Well Name: EL PASO 14 FEDERAL	Well Location: T26S / R30E / SEC 14 / NESW / 32.0405558 / -103.8544985	County or Parish/State: EDDY / NM
Well Number: 1H	Type of Well: CONVENTIONAL GAS WELL	Allottee or Tribe Name:
Lease Number: NMNM93207	Unit or CA Name: 1 EL PASO 14 FED	Unit or CA Number: NMNM101359
US Well Number: 3001530278	Operator: EOG RESOURCES INCORPORATED

Type of Submission: Notice of Intent

Type of Action: Plug and Abandonment

El Paso 14 Fed #1 P&A Procedure**AFE 187082**

Current Wellbore Diagram

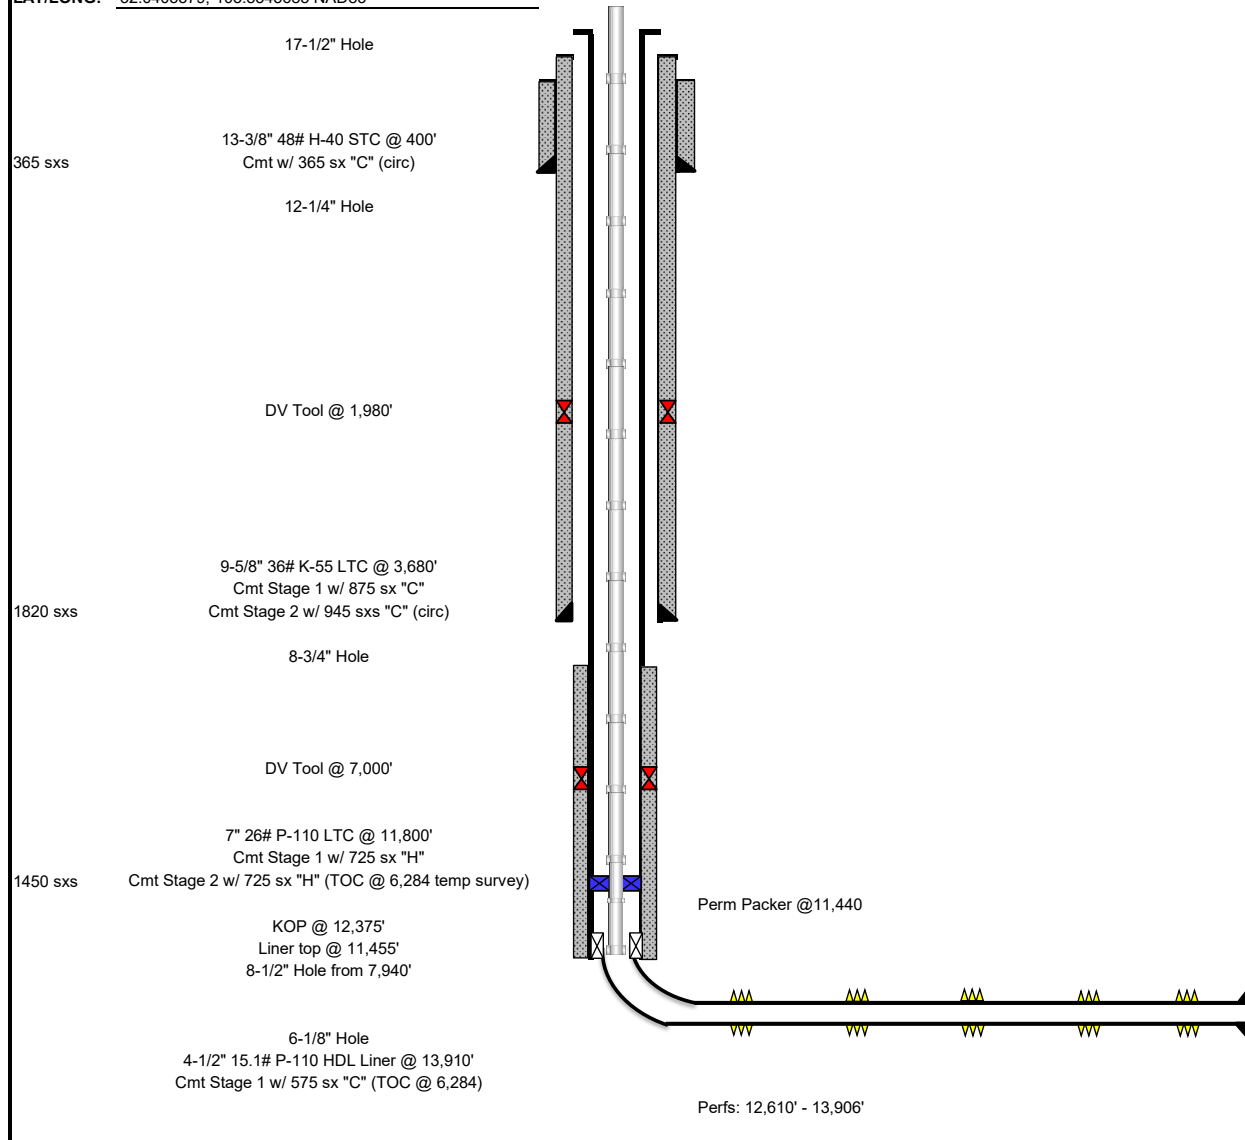
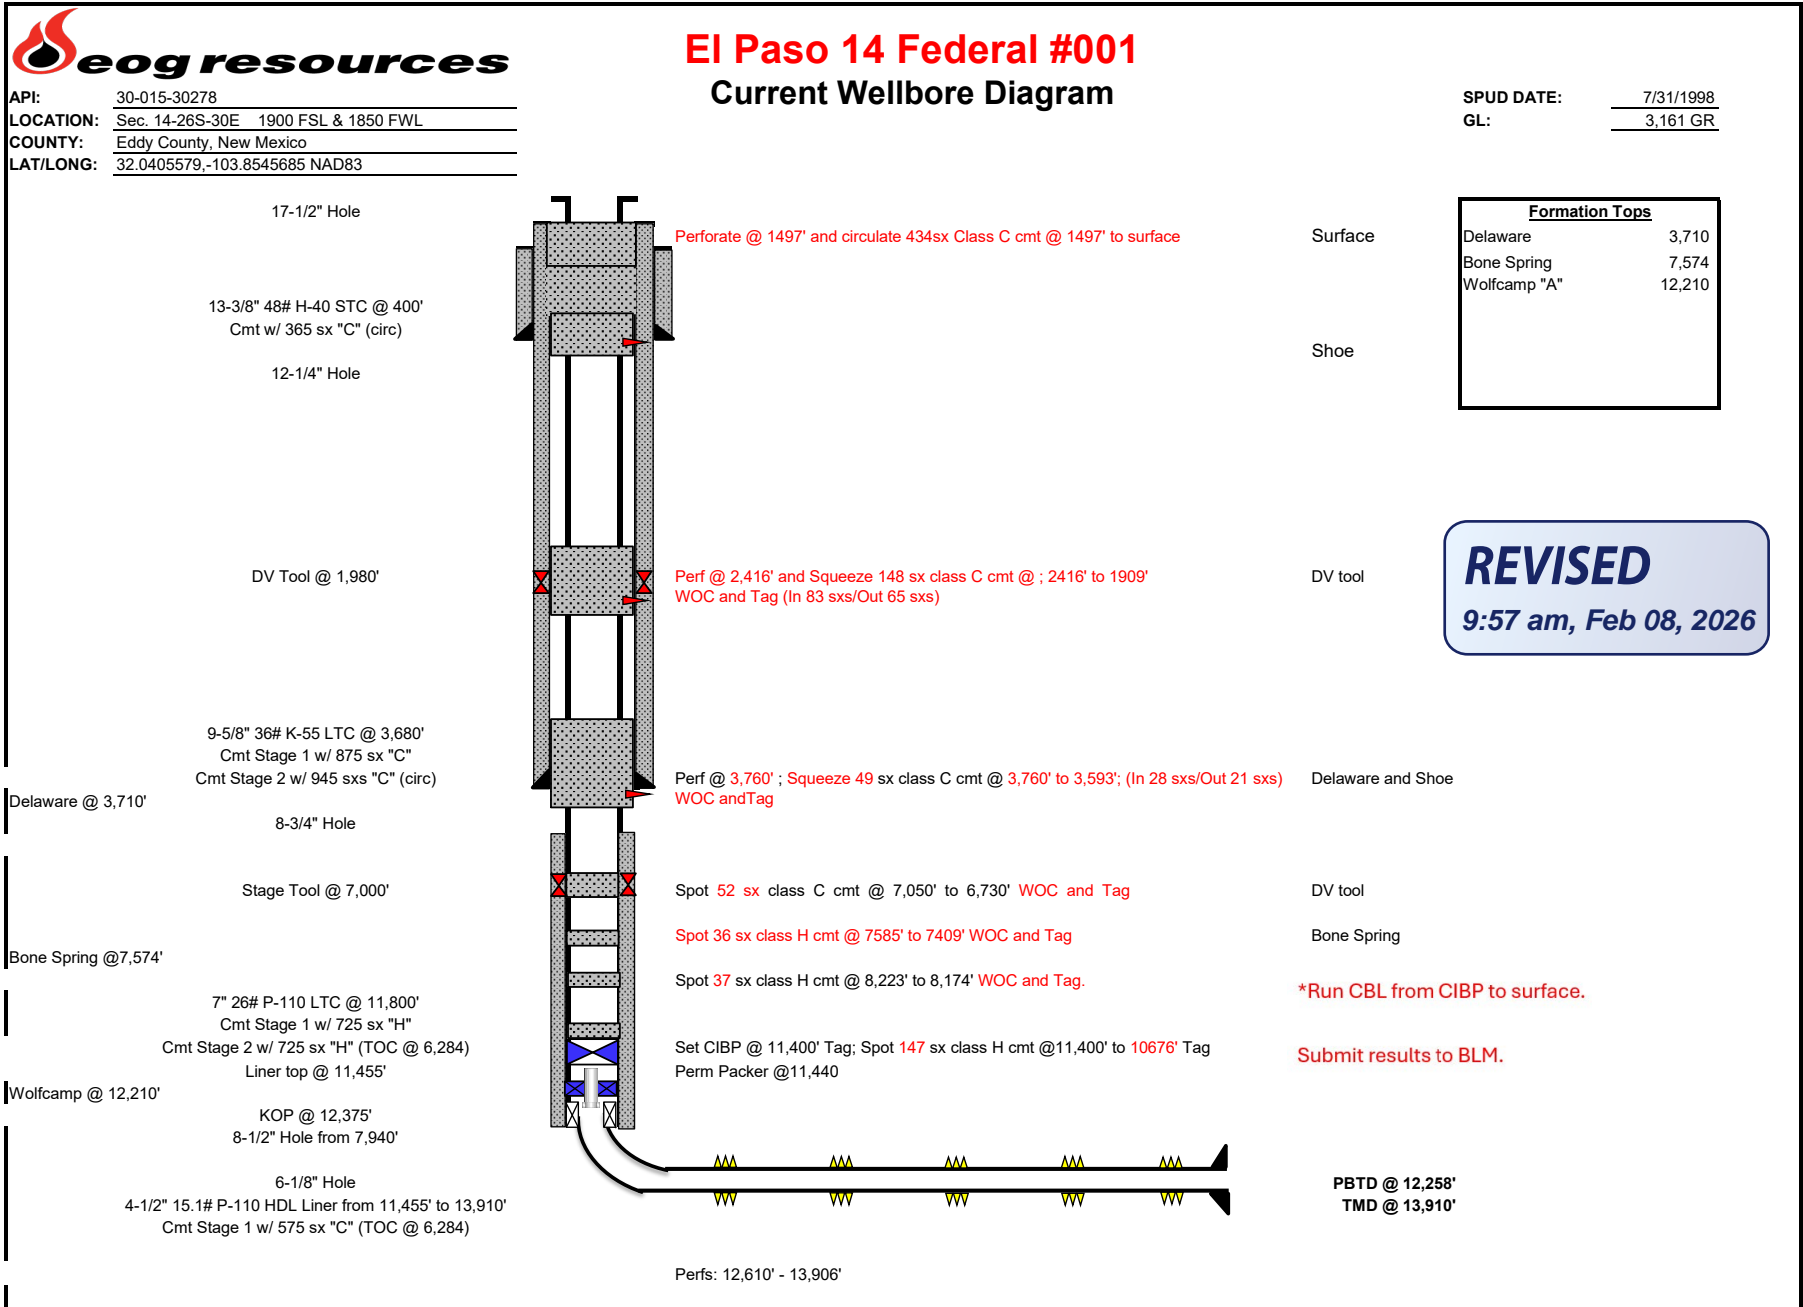
Medium Karst 350'

4. RU WL to make GR/JB run to 11,410'. RIH w/ CIBP and set CIBP at 11,400'. **Leak test CIBP for 30 minutes at 500 psi.**
5. **Run CBL from CIBP to surface.**

6. **Spot 147 sx** of Class H cement on top of CIBP. WOC and TAG **at 10676'.**
7. Spot **37 sx** class H cement 8,223' – 8,174' (spacer plug to make less than 3000 ft between plug) **WOC and Tag**

8. Spot **36 sx** class H cement **7585-7409** (Bone Spring) **WOC and Tag**
9. Spot 52 sx class C cement 7,050' – 6,730' (DV Tool) **WOC and Tag**
10. Pick up, perf @**3,760'** and sqz **49 sx** class C cement plug to 3,592'. WOC and TAG. (Shoe and Delaware) **(In 28 sxs/Out 21 sxs)**

11. Pick up, perf @**2,416'** and sqz **148 sx** class C cement plug to 1,909'. WOC and TAG. (DV tool) **(In 83 sxs/Out 65 sxs)**
12. Pick up, perf @**1497'** and circulate class C cement plug to surface. WOC Bubble Test. **434 sxs.**
